**FIRE SUPPRESSION ASSESSMENT REPORT**

**FUEL TRANSFER INFRASTRUCTURE  
ASSESSMENT  
Red Hill Bulk Fuel Storage Facility, Hawaii  
(RHL)**

## FINAL SUBMITTAL

Delivery Order No. N3943022F4333  
A/E Contract No. N39430-20-D-2242

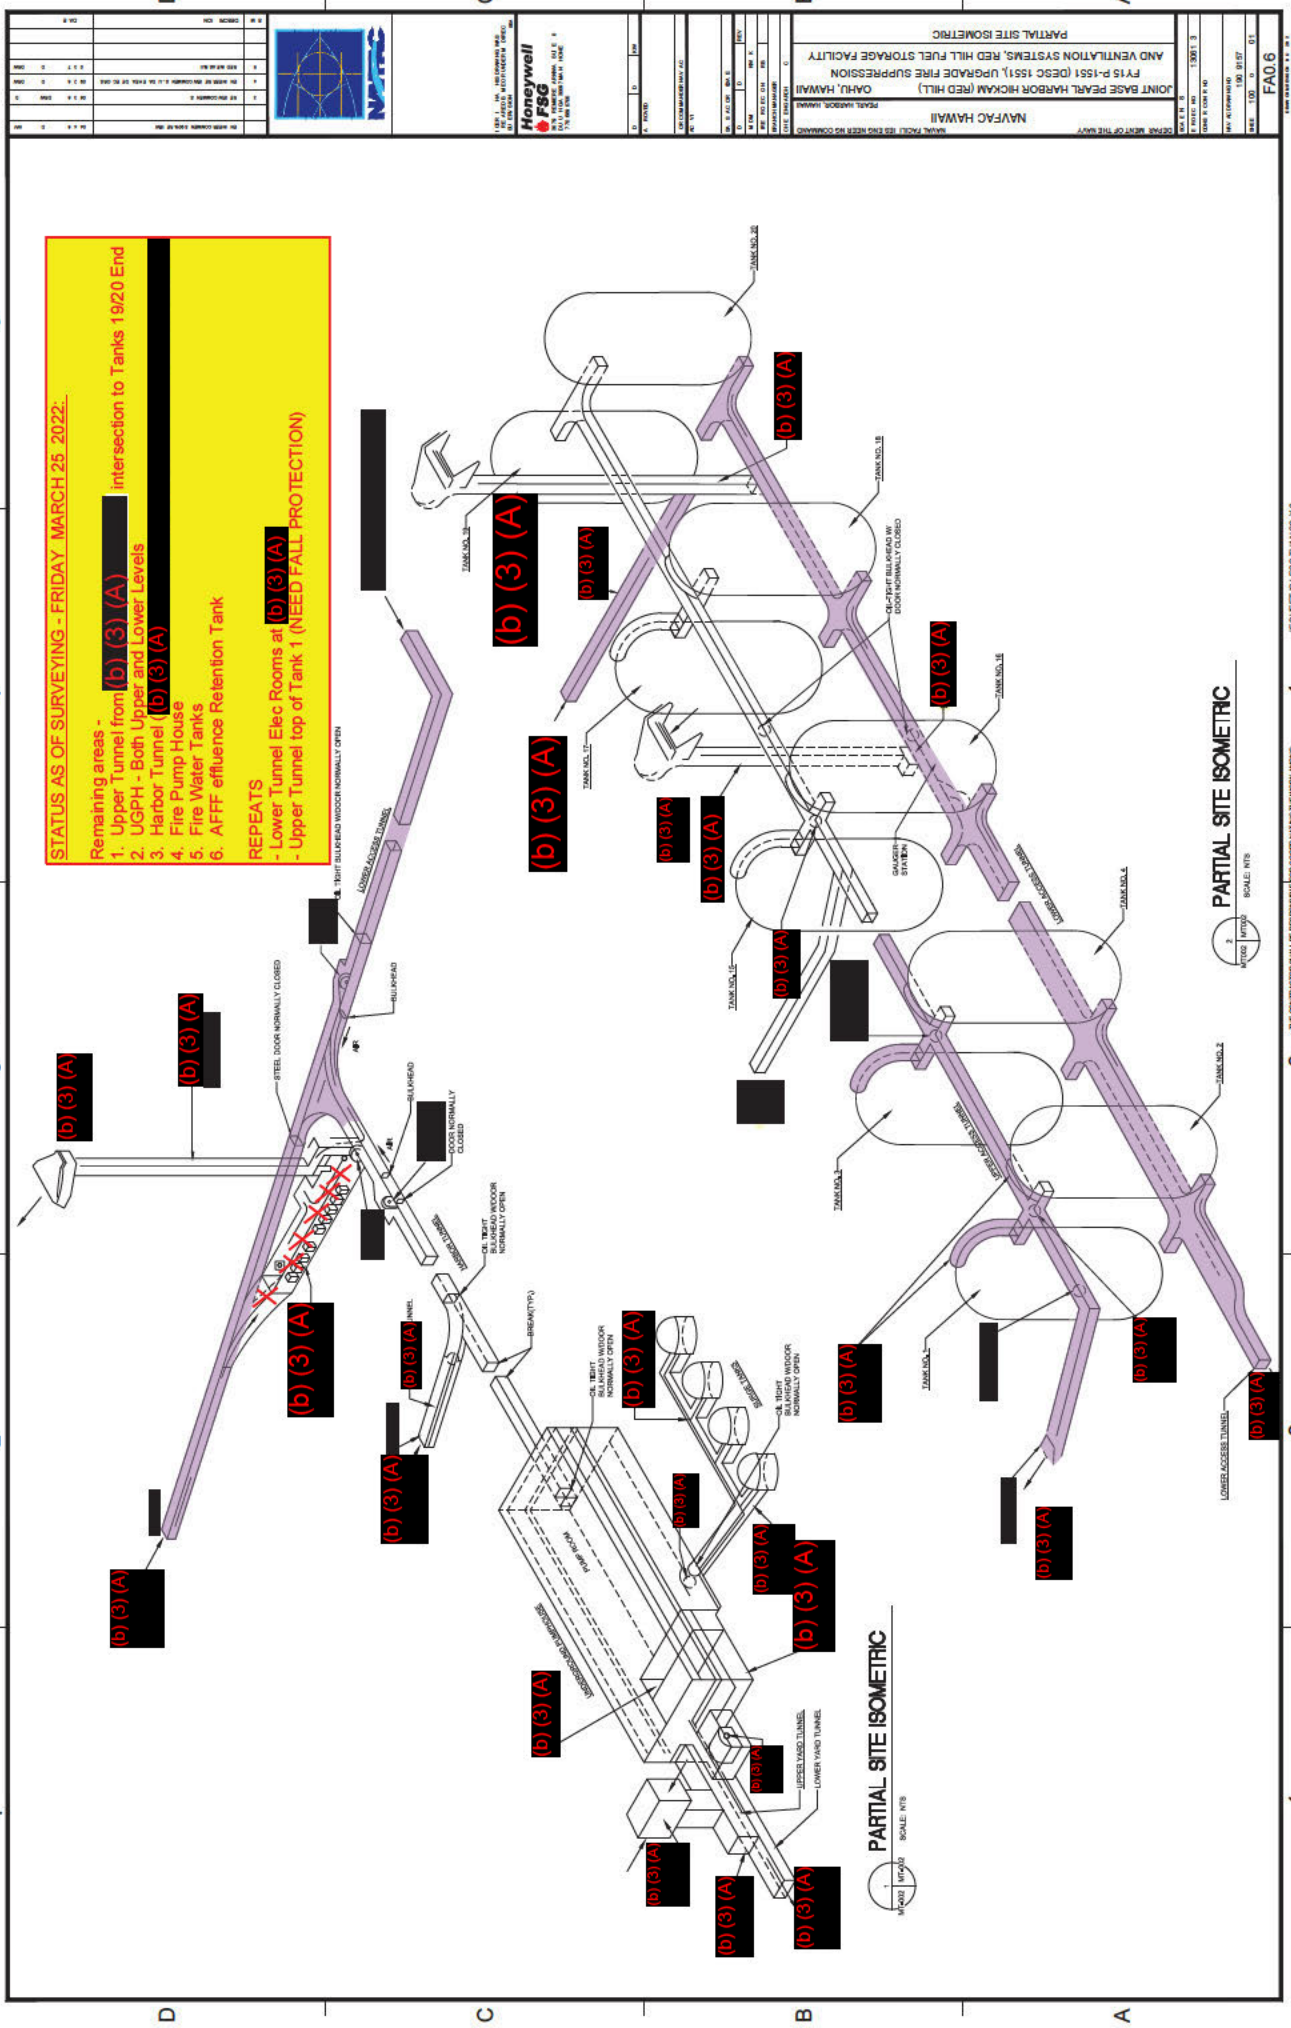
Section of tunnel from UGPH  
to Harbor Tunnel  
intersections needs to be as  
built.

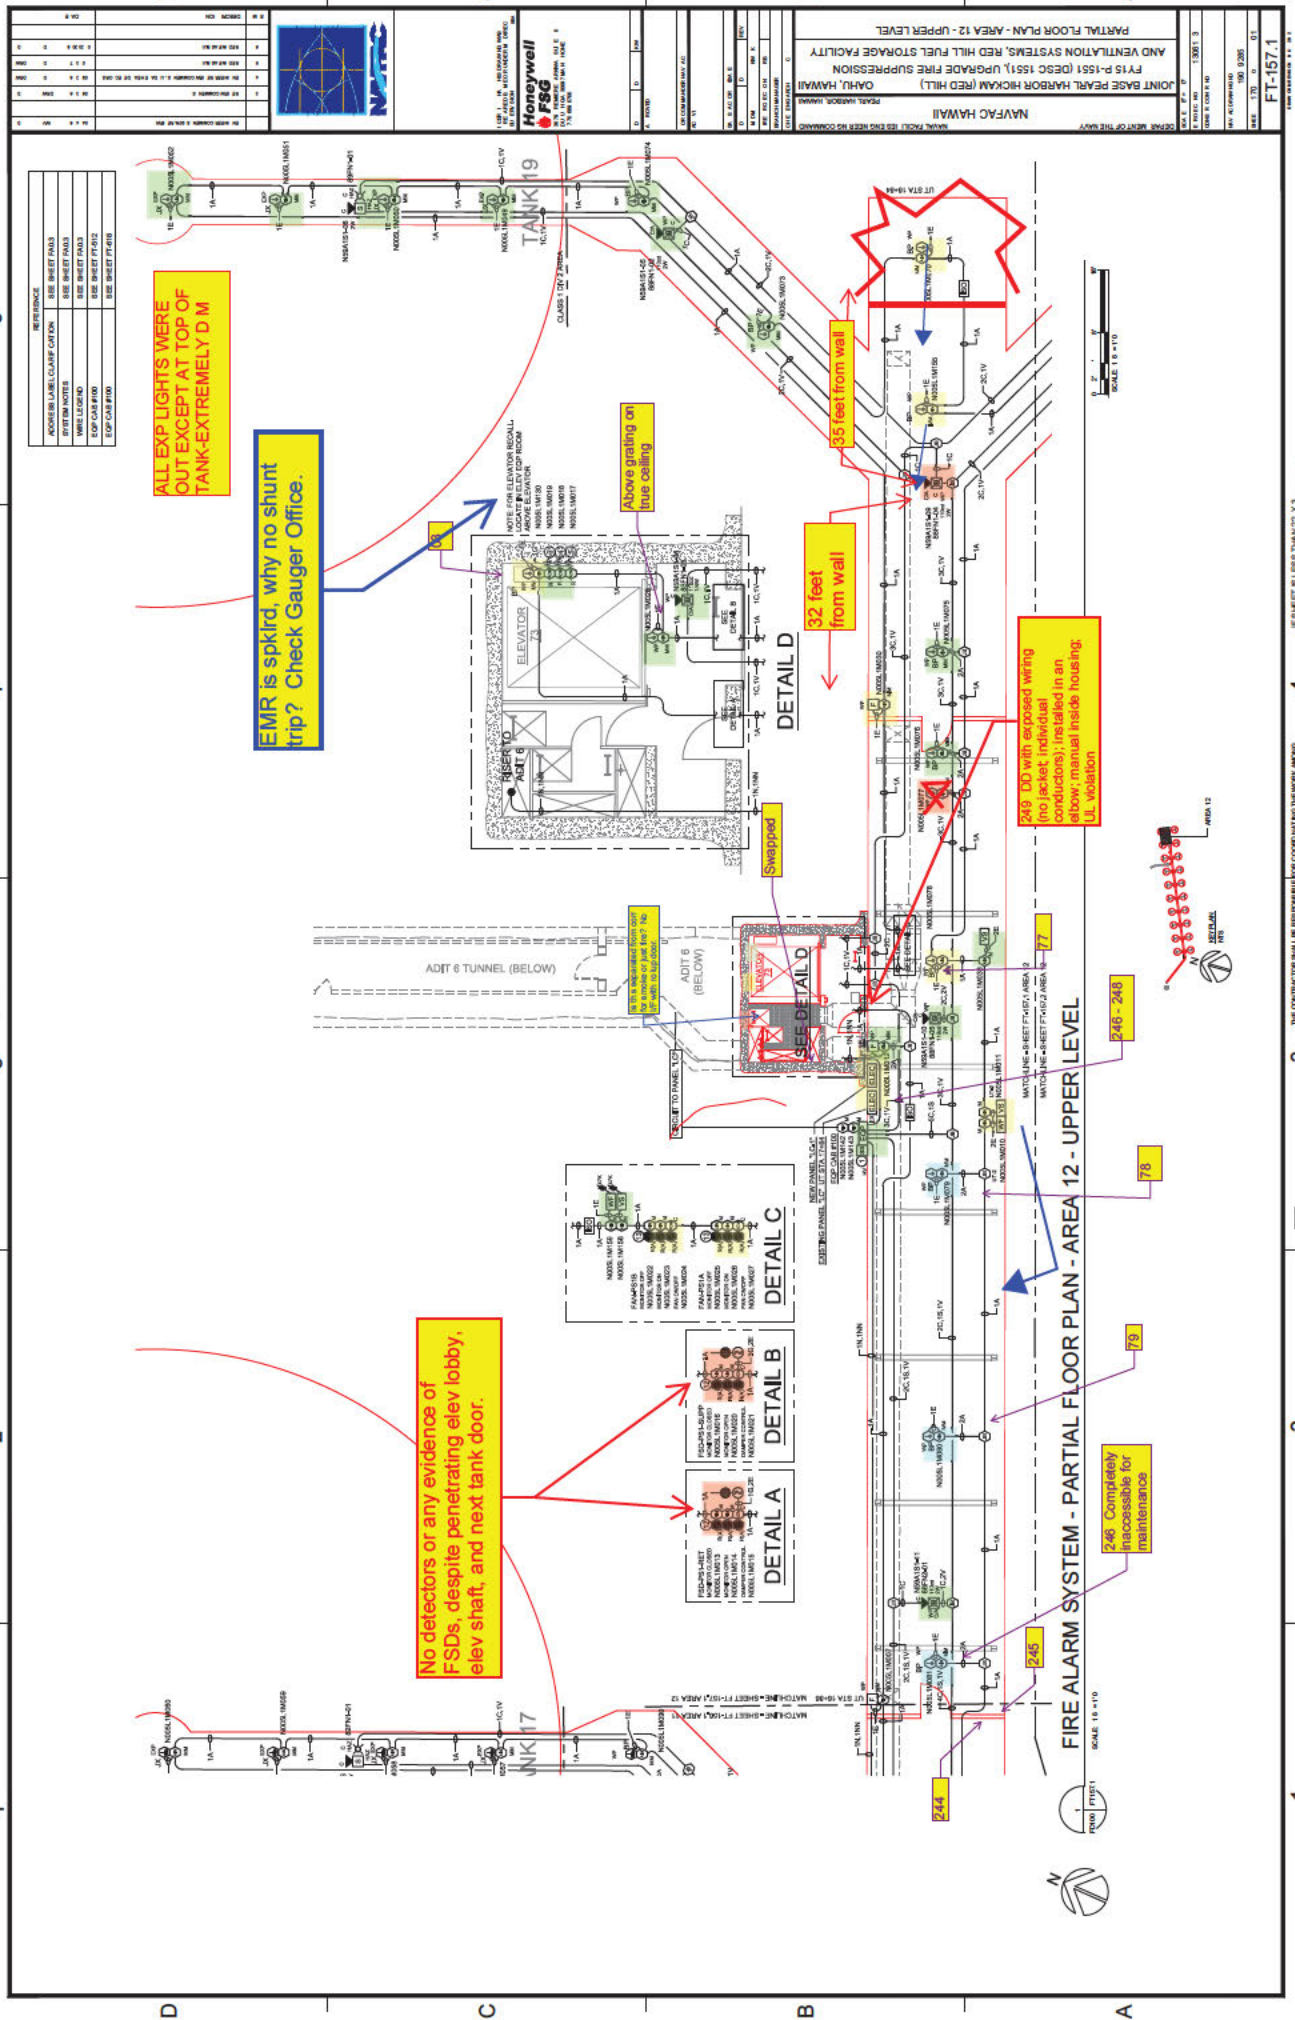
ALL EXPLIGHTS WERE  
 OUT EXCEPT AT TOP OF  
 TANK-EXTREMELY D.M.

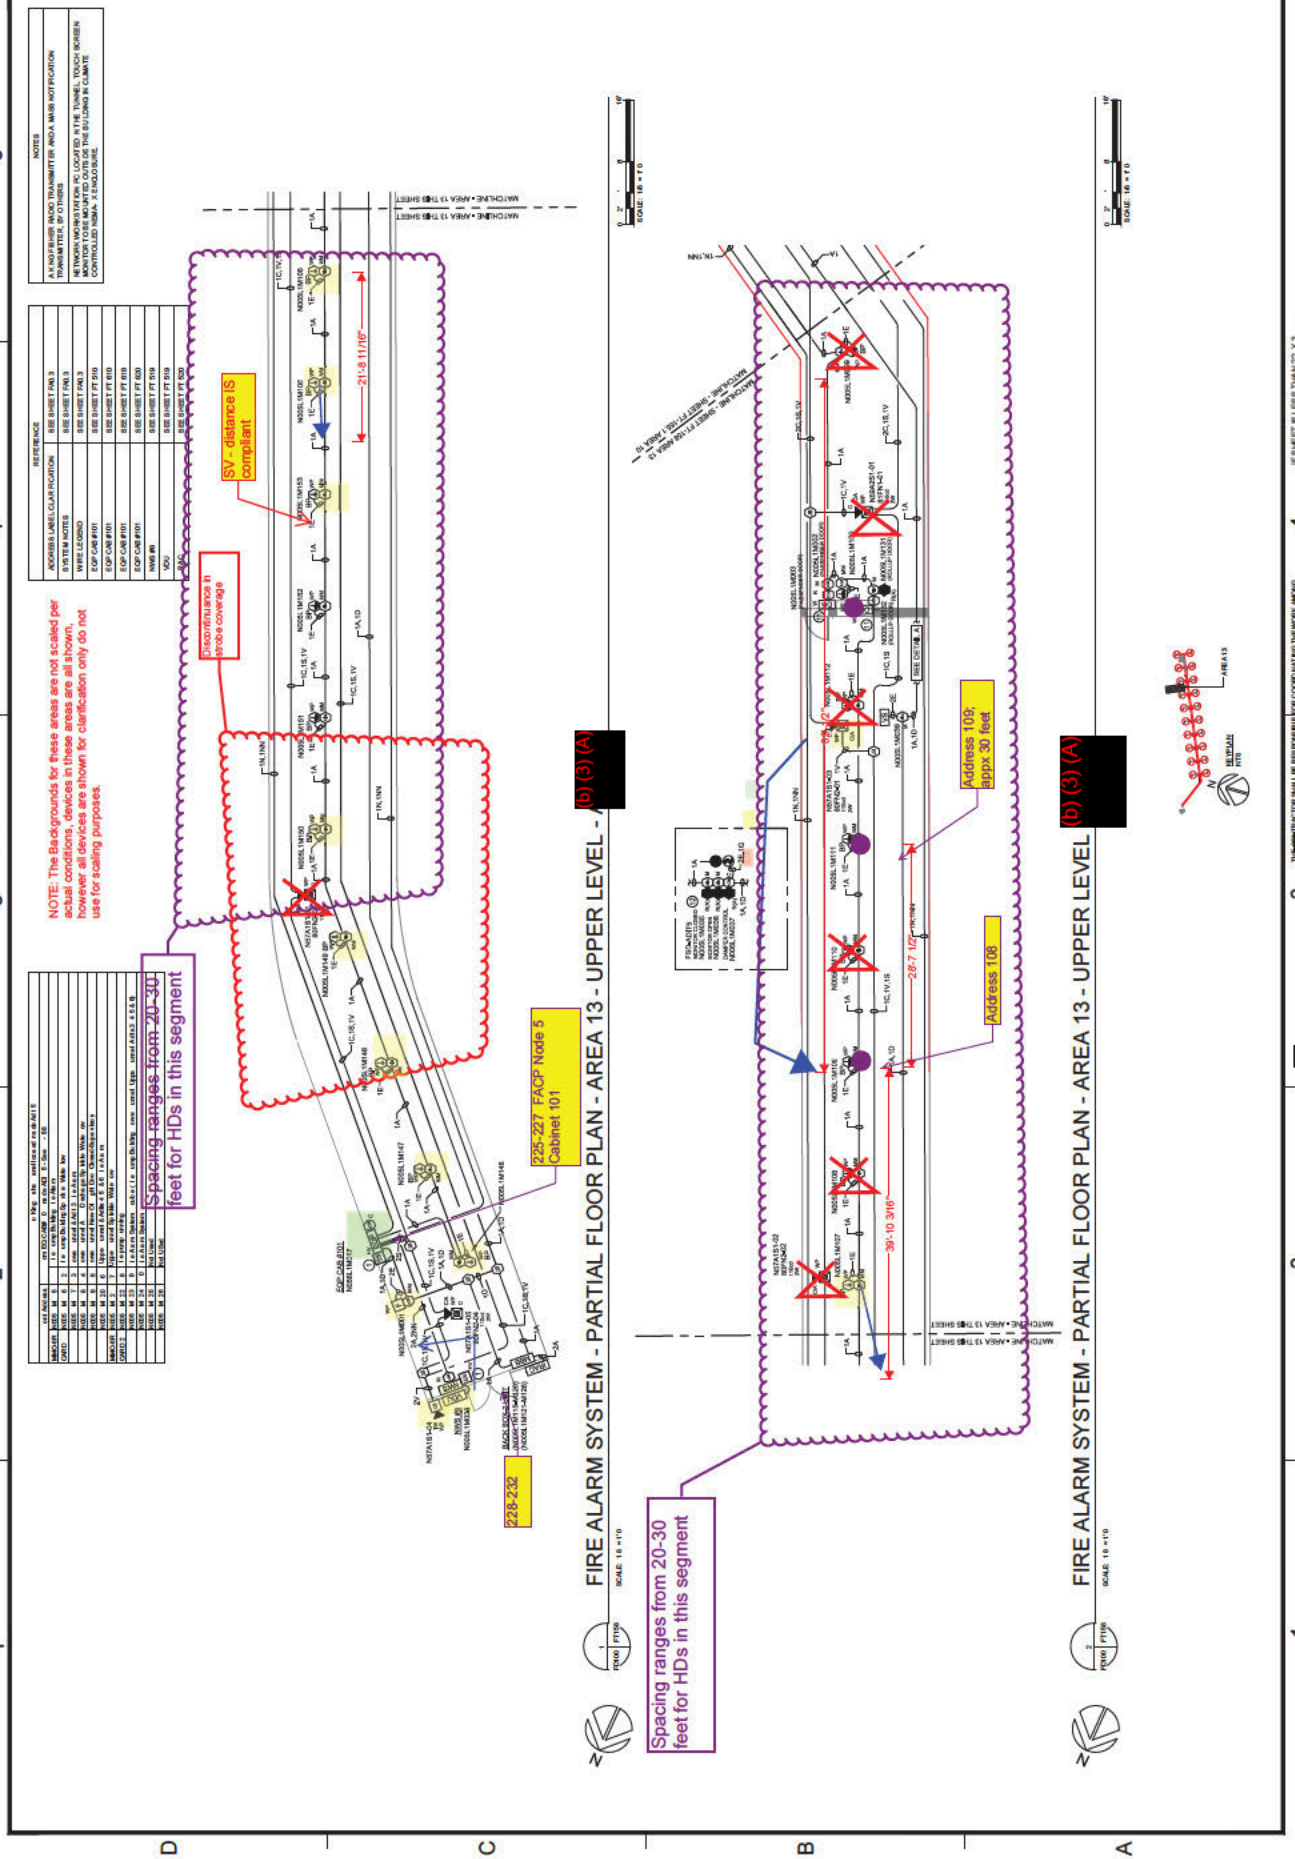
249 DO with exposed wiring  
 (no jacket, individual  
 conductors); installed in an  
 elbow; manual inside housing;  
 UL violation
